**Re: S216-011 MANATEE ISLES PLAT
RESPONSE TO STAFF REPORT FINAL COMMENTS**

Our office is in receipt of comments received on July 19, 2018 in regards to the Manatee Isles Plat application. This letter represents our response to the comments received regarding the Development Review Staff Report. Each comment is identified below followed by a response in **bold italics**.

10250 VILLAGE PARKWAY UNIT 201 PORT ST. LUCIE, FL 34987	
☎️ 772-462-2455	
S-17-284	
1 OF 1

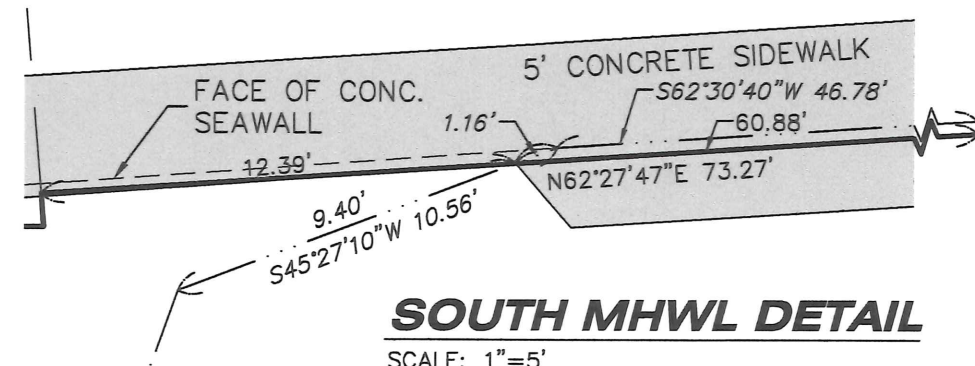
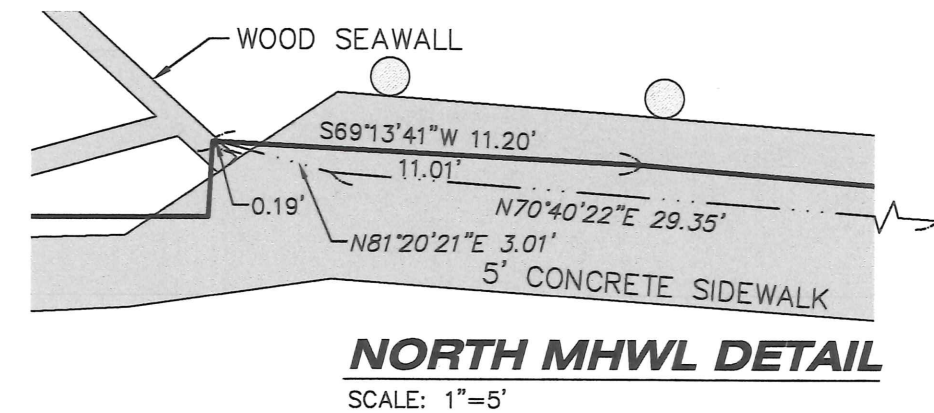
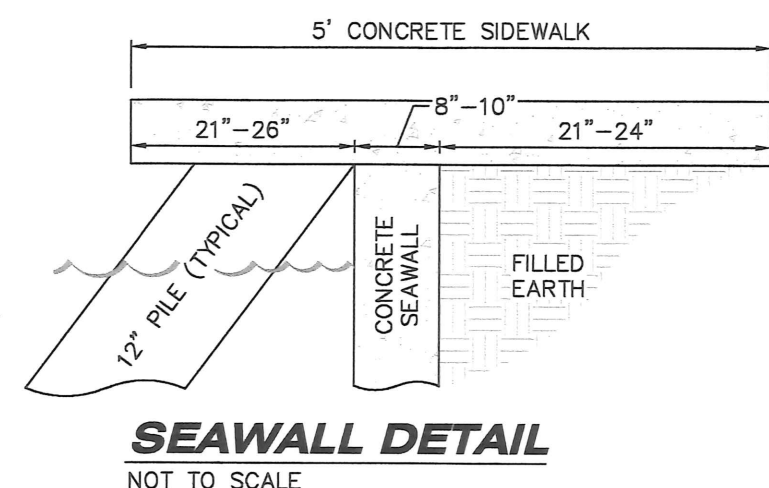
Provided Boundary Survey is not certified and does not include a title opinion of an attorney or certification by an abstractor. Boundary Survey also does not show the Point of Commencement or Point of Beginning. Insure Survey meets all Standards of Practice.

Address Mean High Water Line requirement of the plat.

RESPONSE: *Please see the revised boundary survey which includes certifications and title opinion of an attorney. The points of commencement and beginning are also depicted on the revised boundary survey.*

RESPONSE: *The mean high waterline follows the seawall, which meanders in and out of the described property limits at courses very similar to the recorded legal description. The described property line will be monumented. See attached boundary survey for mean high waterline location.*

SURVEYORS NOTES

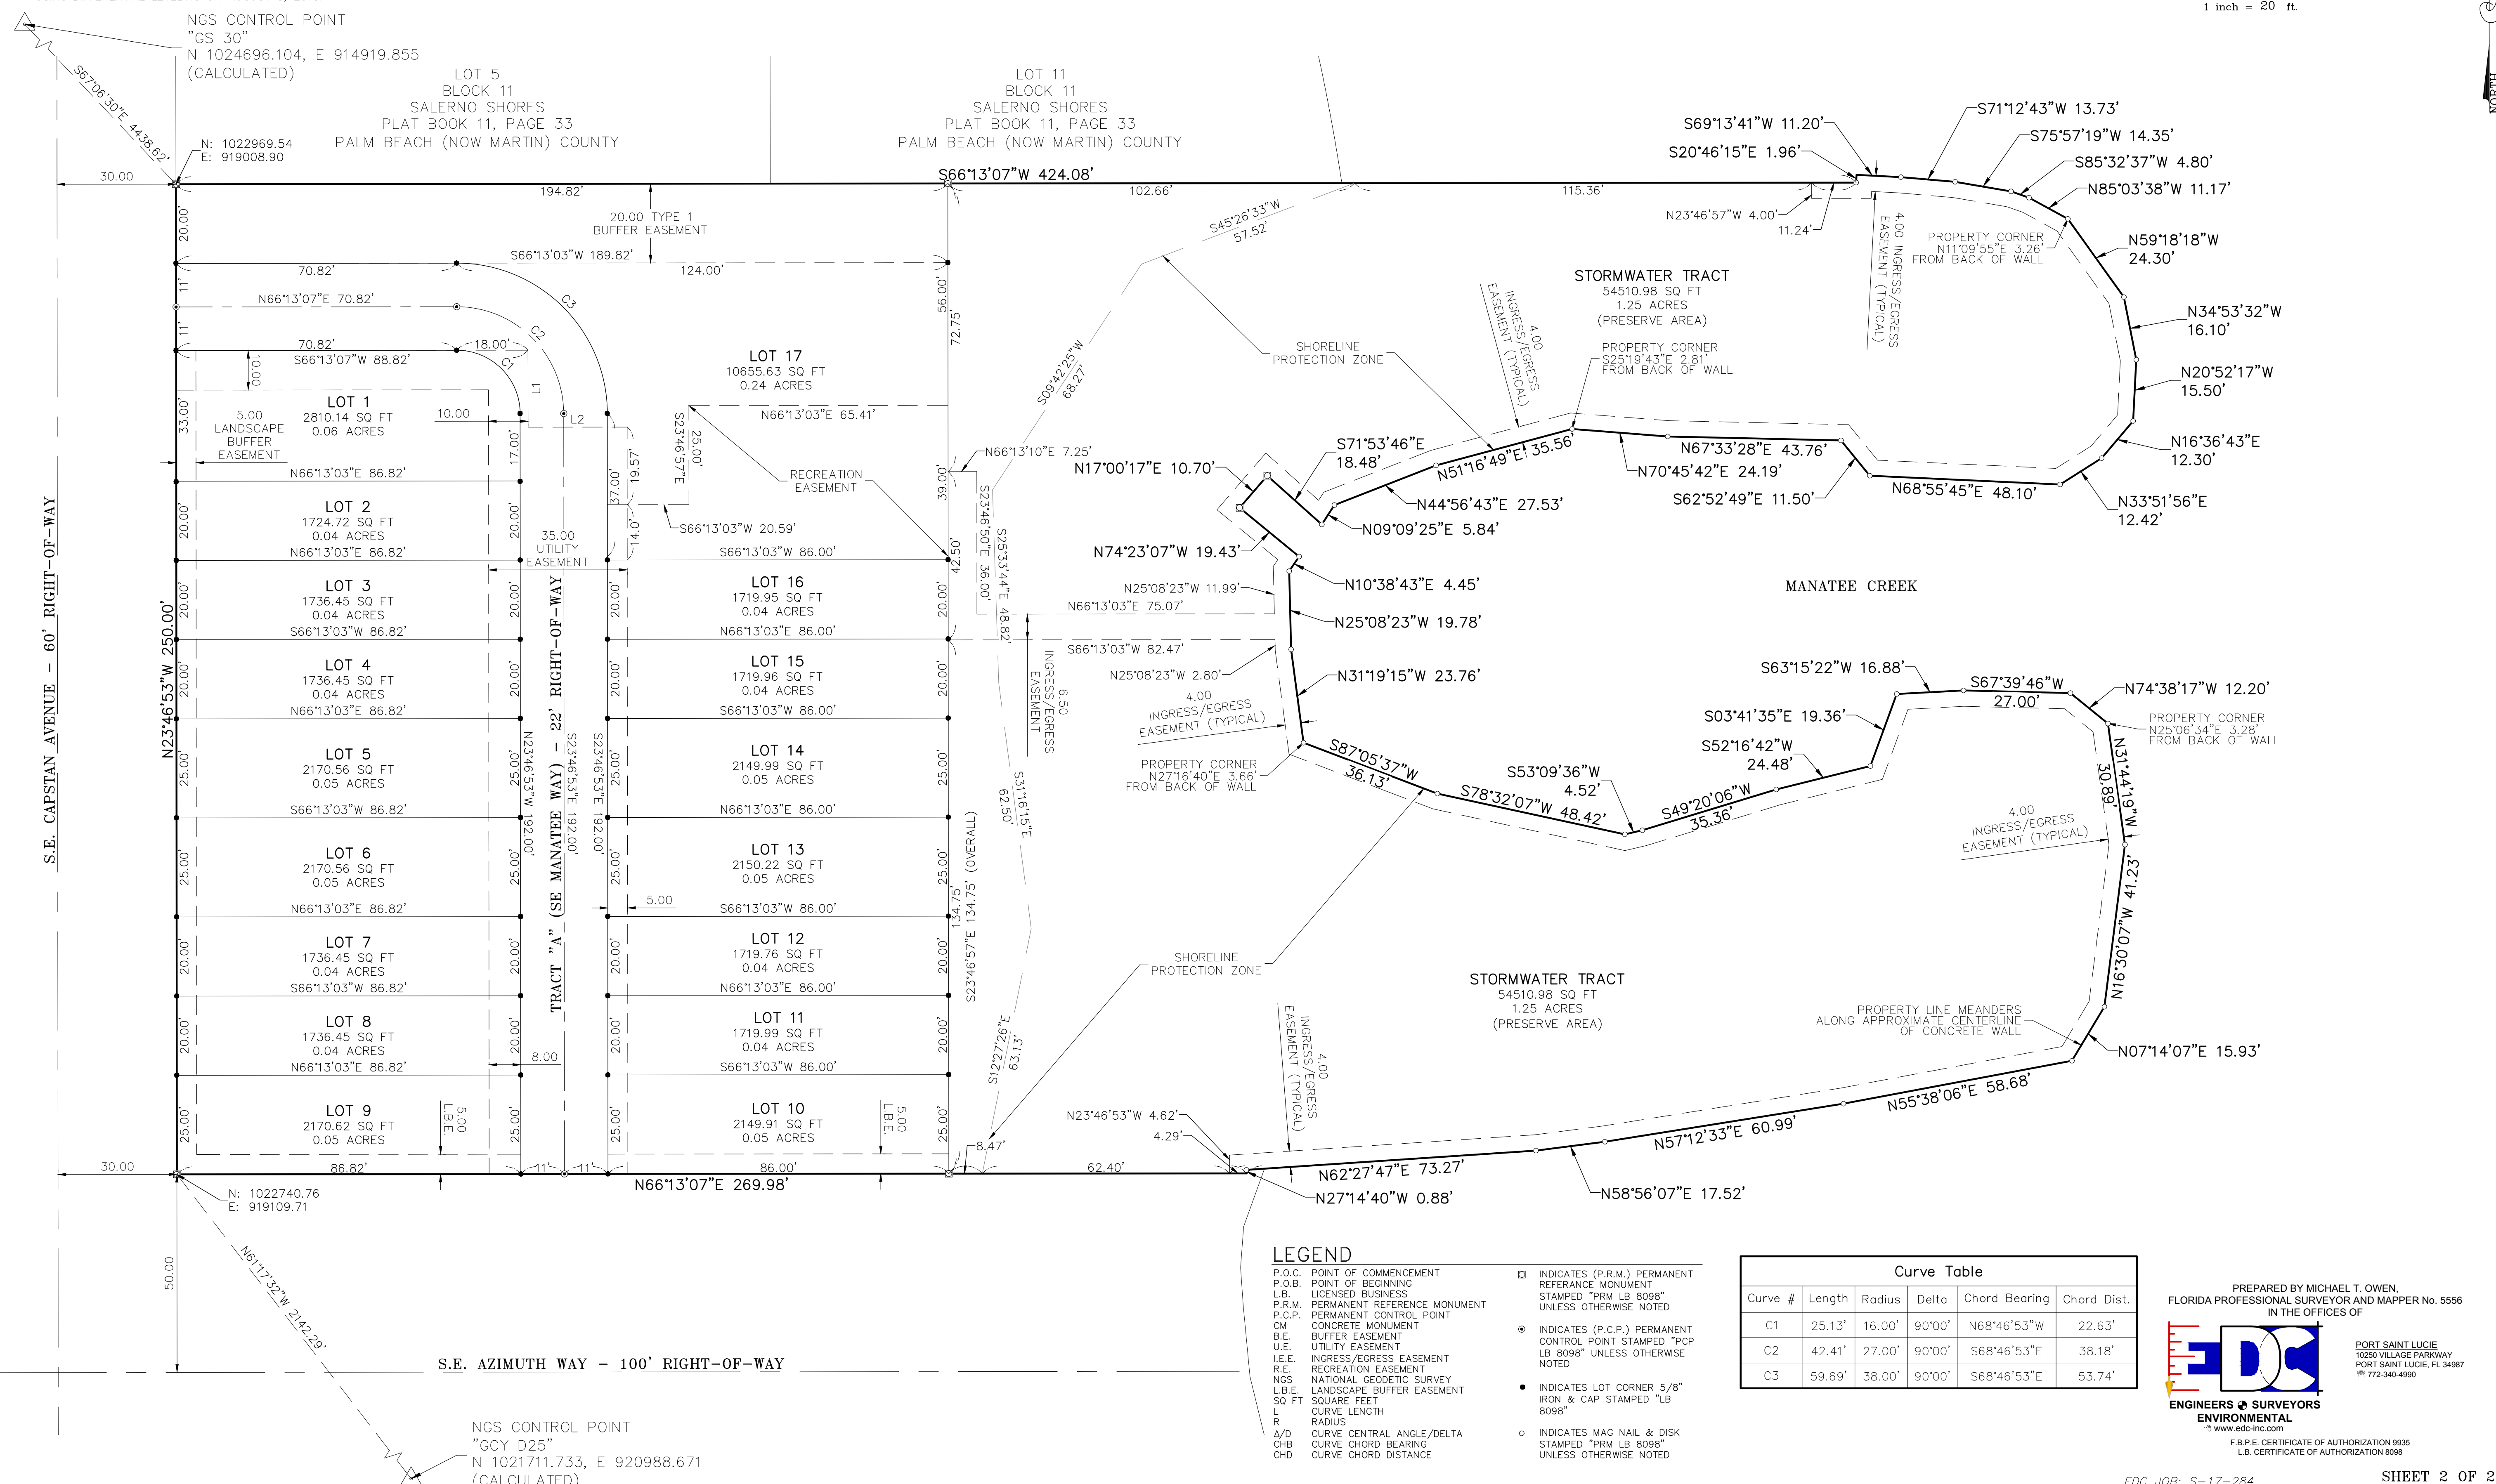
The plat shall be consistent with the approved final site plan and construction drawings. The preserve area (SPZ) shall be clearly identified and labeled on the plat. In the dedication section, the plat shall make reference that the preserve areas will be managed in accordance with the approved preserve area management plan (PAMP). Please revise accordingly.

The abbreviation used for square feet are not consistent between Plat and Legend. Eliminate items from legend that are not used on the Plat.

The date of the field survey is not shown on the plat.

Provide State Plane Coordinates on a minimum of 2 PRMs.

Drill Holes are not adequate for changes in direction on the boundary. Set adequate PRMs. Nail and disk stamped "PRM LB 8098" would be acceptable.

Chords and Chord Bearings not labeled on lot lines and street center lines.

Please add SE to Manatee Way.

RESPONSE: Please see revised plat which address the above comments.

RESPONSE: *Please see revised plat which addresses the above comments.*

RESPONSE: *Please see revised plat.*

RESPONSE: *Please see revised plat.*

RESPONSE: *Please see revised plat.*

RESPONSE: *Please see revised plat.*

RESPONSE: Please see revised plat.
